UNITED STATES PATENT AND TRADEMARK OFFICE

Office Action Summary	Application No. 10/667,655	Applicant(s) ELLIOTT, NYLE S.	
	Examiner Adam Marcetich	Art Unit 3761

DETAILED ACTION

Annotated Fig. 2 of Ravo (US 5,108,430)

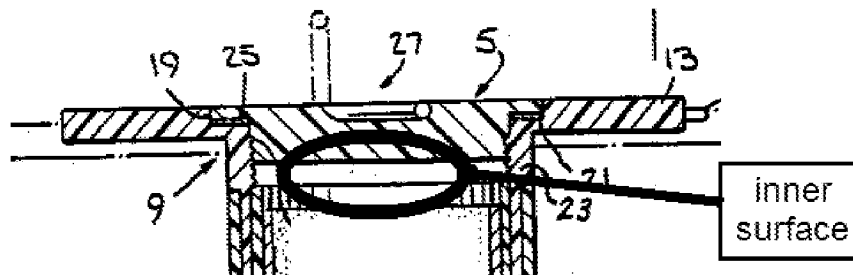
21. A rearrangement of conductors from a pad member to a plug is not sufficient to distinguish over prior art. One would be motivated to modify to conductors of Ravo and Millot to detect wetness or fecal matter in a desired location since the colon may not distend sufficiently to trigger the alarm of Ravo. That is, by extending third and electrical conductors within the plug of Ravo, wastes can be detected within a plug even when a colon does not distend enough to trigger an alarm.

22. Regarding a limitation of third and fourth conductors comprising a pair of spaced apart rings, Millot suggests that ring are a suitable shape for spacing conductors about an aperture (col. 3, lines 39-45, Fig. 2, electrodes 17, 18 on tracks 15 and 16 forming circle arc). The claimed “upwardly extending section” between upper and lower rings of claims 21 and 22, along with the “first section” of claim 23 are interpreted as auxiliary or supporting connections lacking criticality. For example, Ravo expedites disclosure by briefly referring to additional or supplementary or secondary conductors and does not depict them (col. 5, lines 33-40).

23. Additionally, a limitation of a plug having a lumen [claim 22] provides clearance for wastes to contact conductive surfaces. That is, a cylindrical depression or cavity ensures space for wastes to move through the cylinder and contact sensors before reaching the furthest distal edge.

24. Therefore, it would have been obvious to one of ordinary skill in the art at the time the invention was made to rearrange the conductors of Ravo and Millot in order to

detect wastes that have contacted a plug and not sufficiently distended a colon. See MPEP 2144.04(VI)(C).
